30" PCCP SEWER FORCE MAIN REPLACEMENT

INVITATION FOR BID # PSUT-26-02

F - PSUT-26-02 – 30” PCCP Force Main Replacement - Addendum #1

THIS SHEET NOT VALID FOR CONSTRUCTION WITHOUT COMPLETE SET OF PLANS. SEE GENERAL NOTES FOR MASTER LEGEND.
Sheet No.
C-0

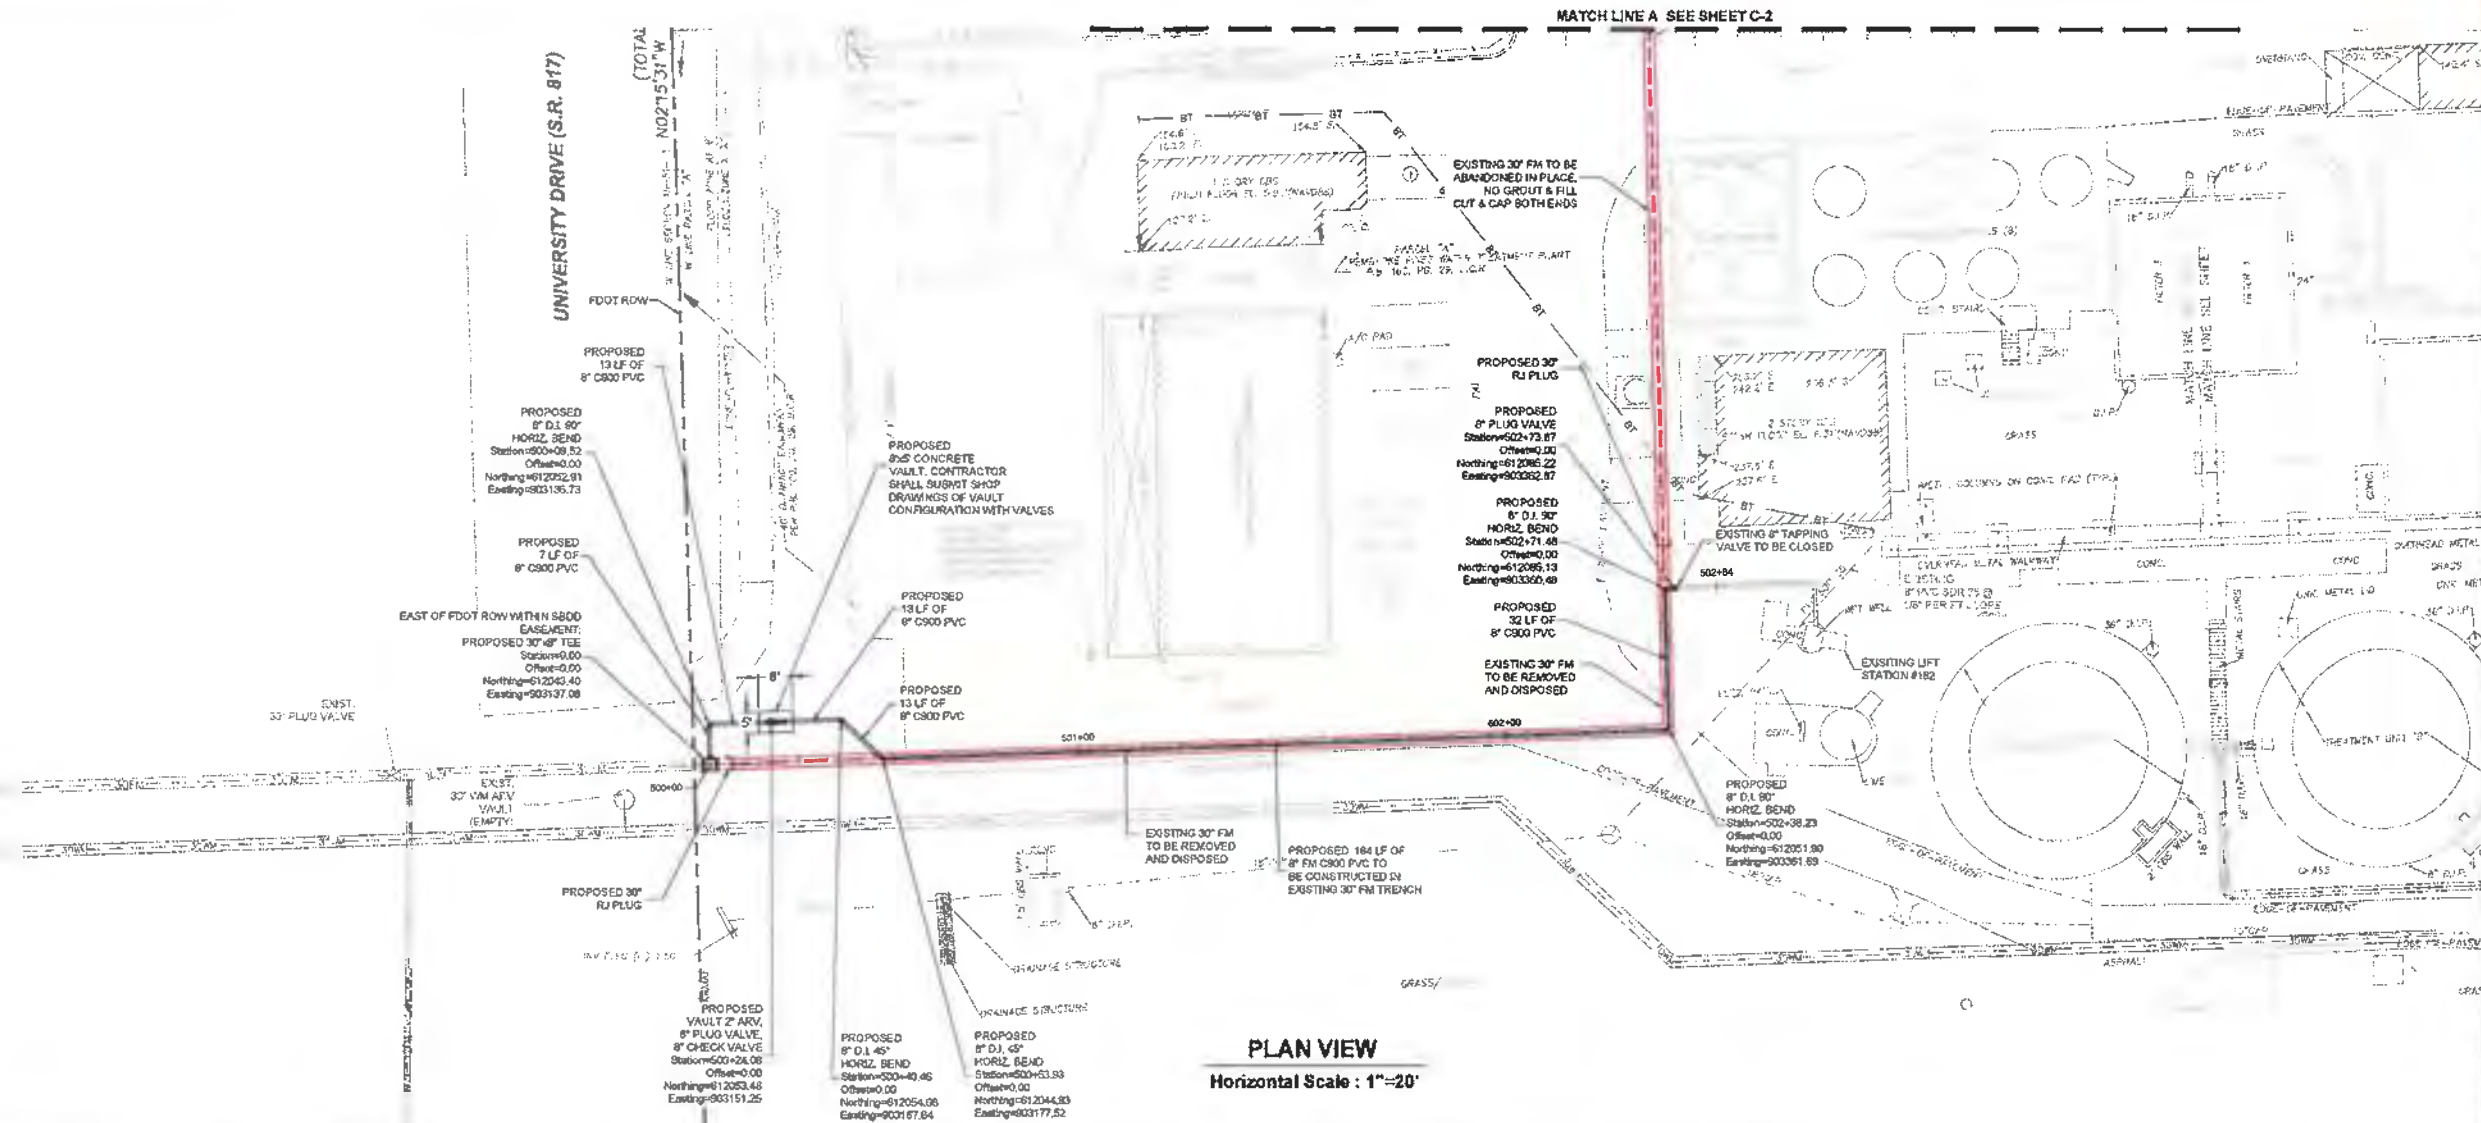
1. Sheet C-0 and C-1 – Note #4; This note includes, but is not limited to, bypass pumping and hoses to maintain existing Lift Station service during construction, utilizing the existing lift station pumps.

Question: On Sheet C-0, please advise if the existing 30" FM to be abandoned is to grout filled.

Answered : Refer to bid plans sheet C-0 and C-1 for further clarification.

Sheet No.
C-3

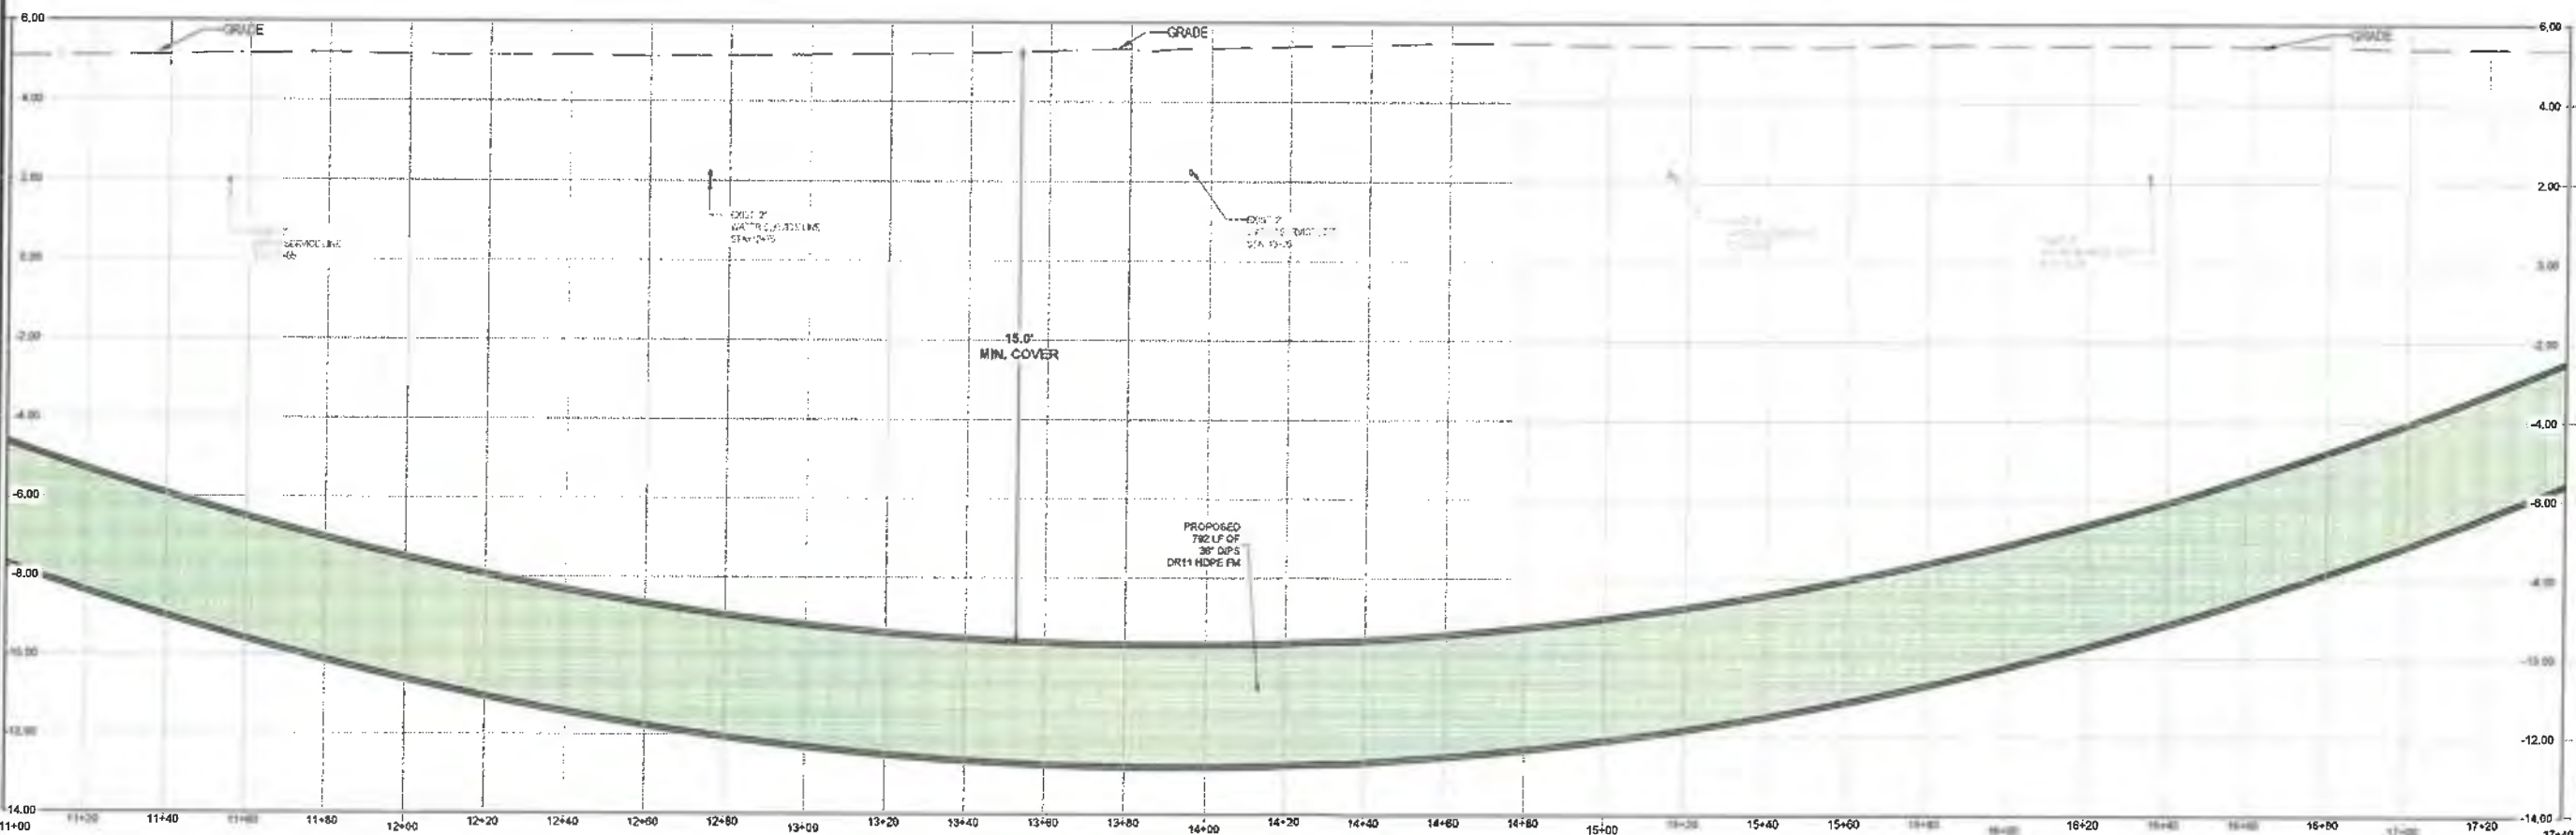
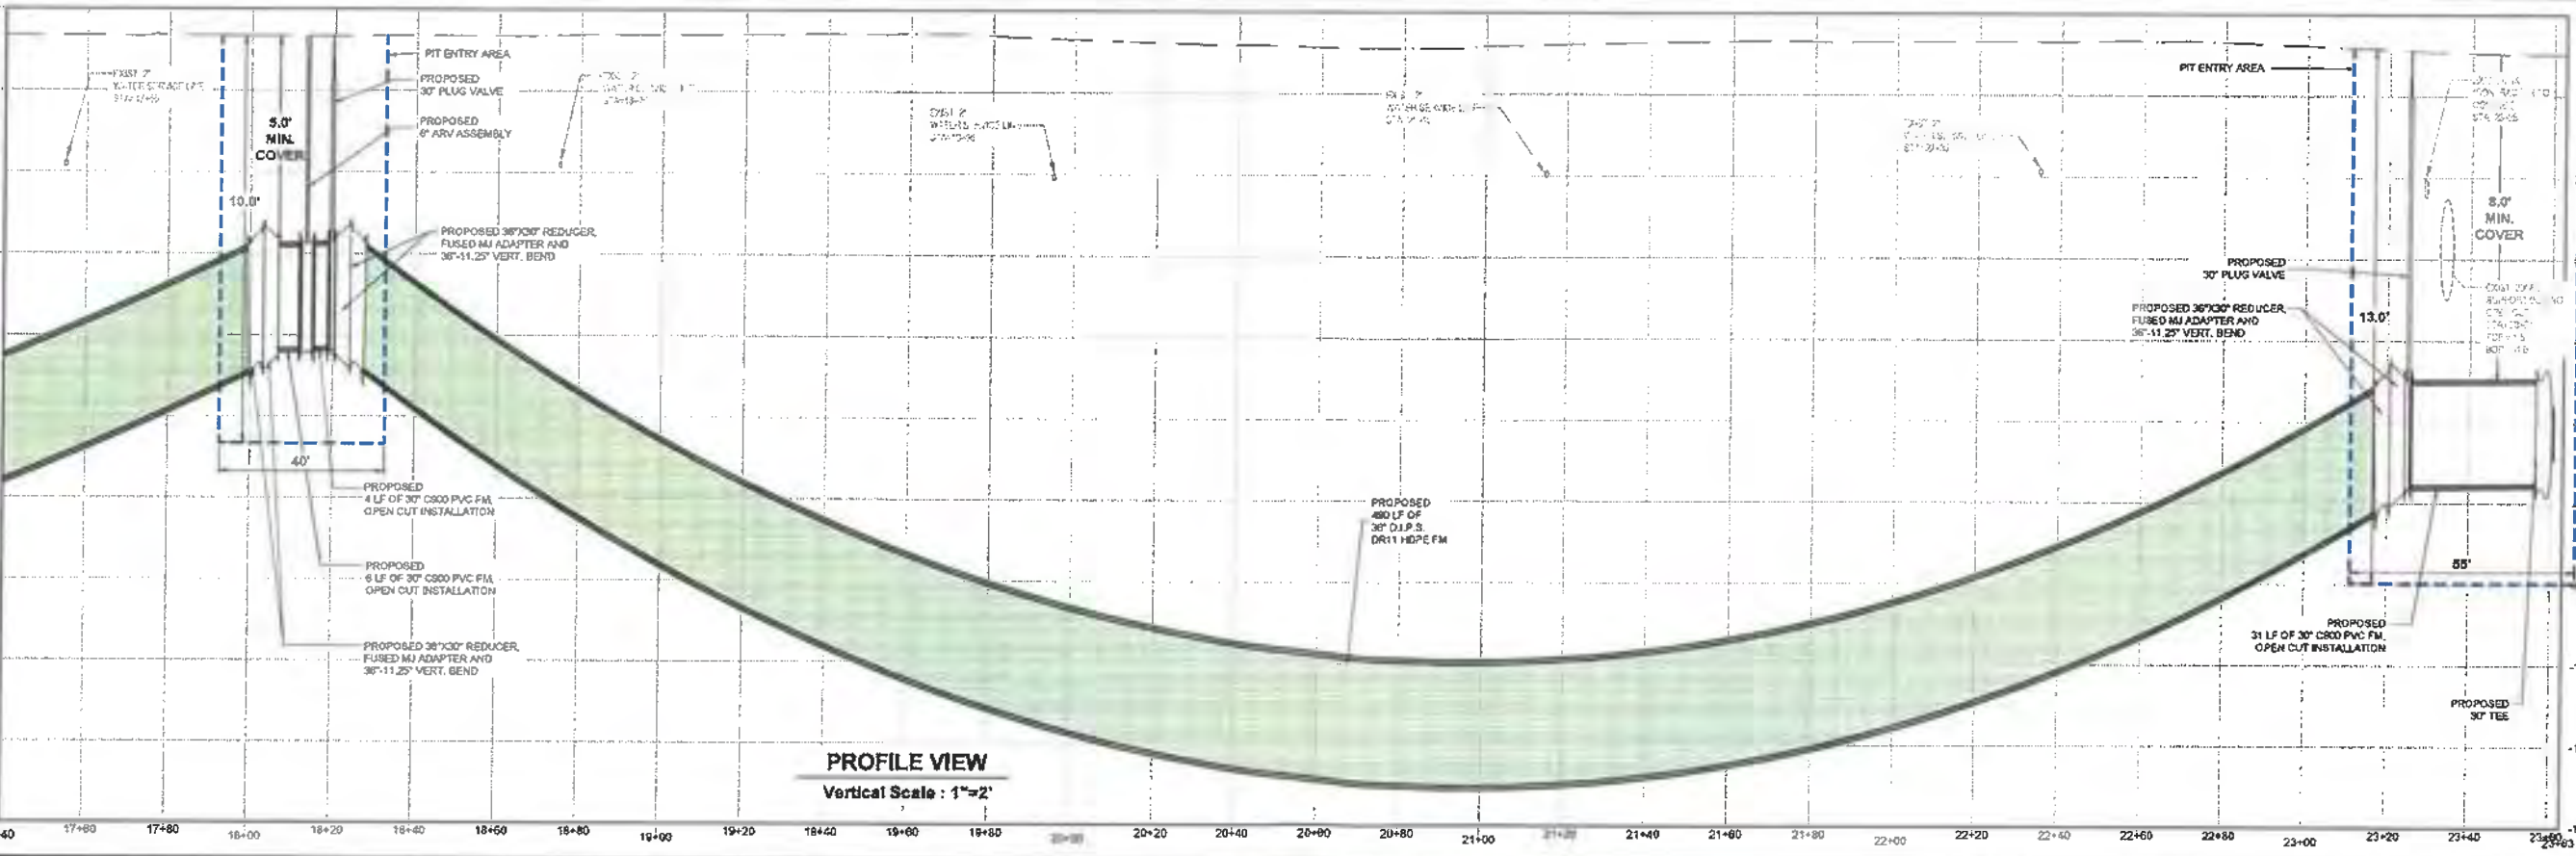
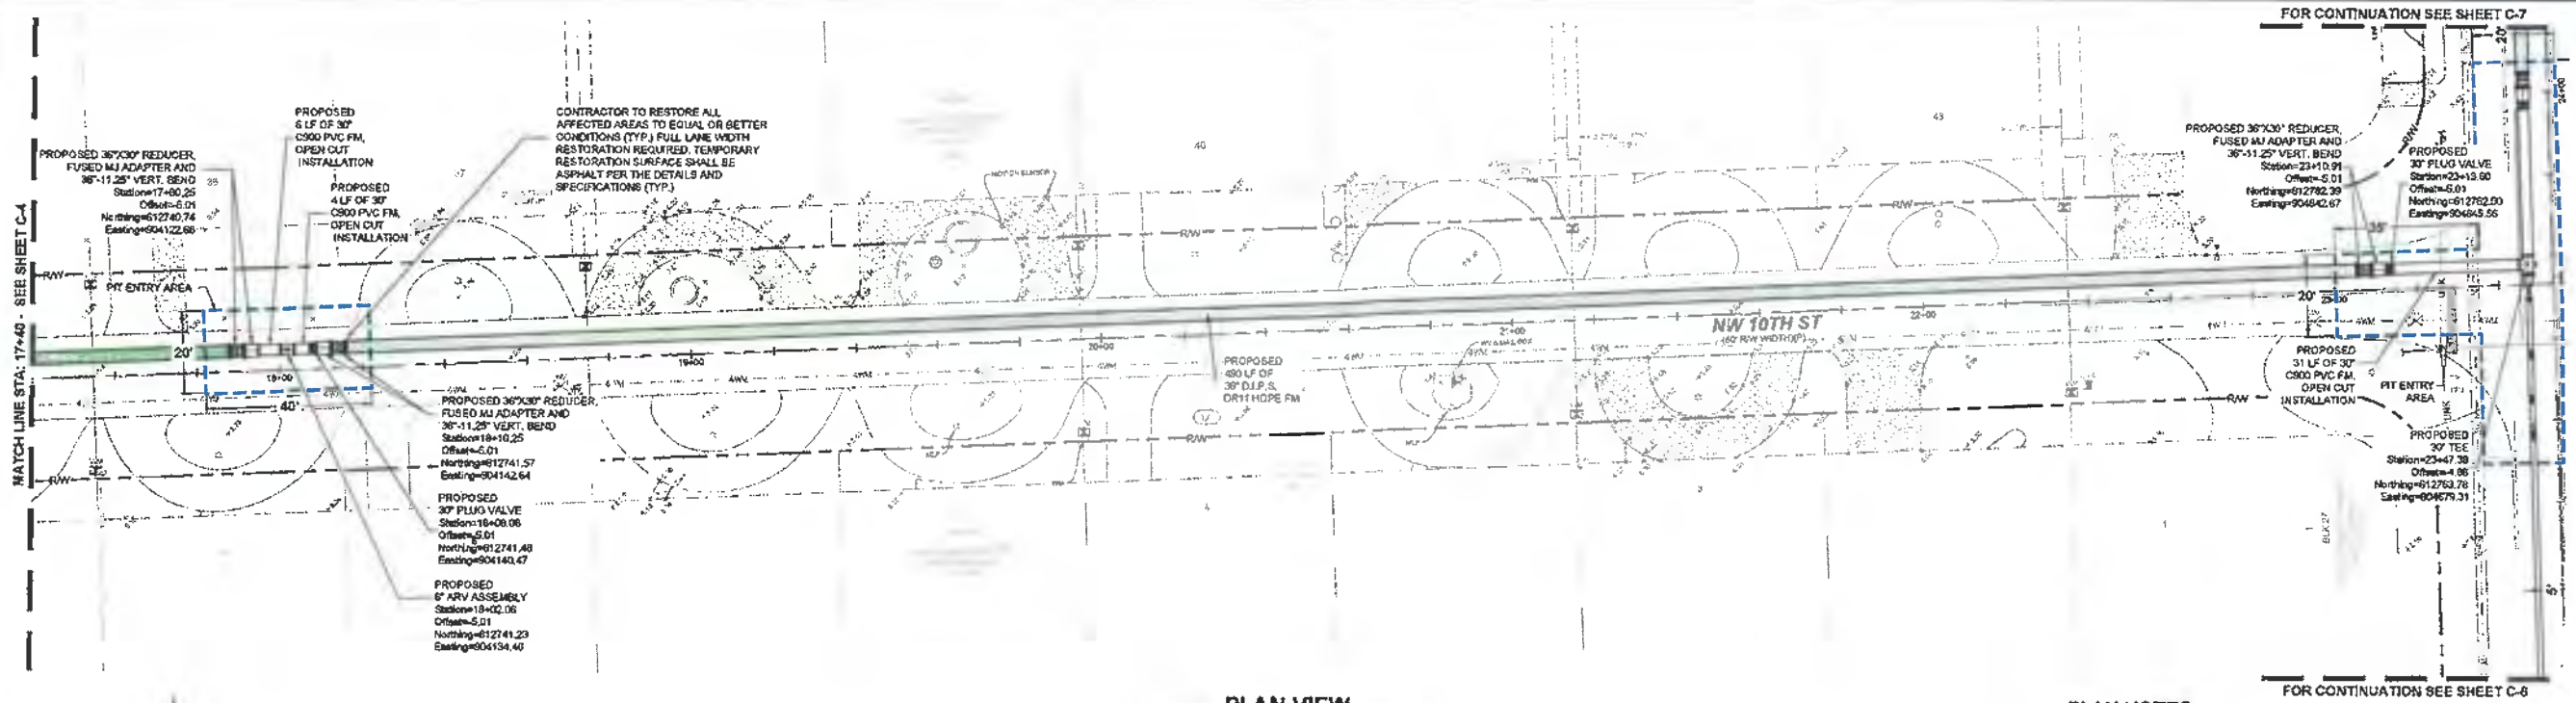
2. Sheet C-2 - Attention is drawn to the symbology of existing concrete power poles and other utilities shown in the pit entry area. The Contractor shall coordinate with utility owners and ensure safe shoring and support as necessary.
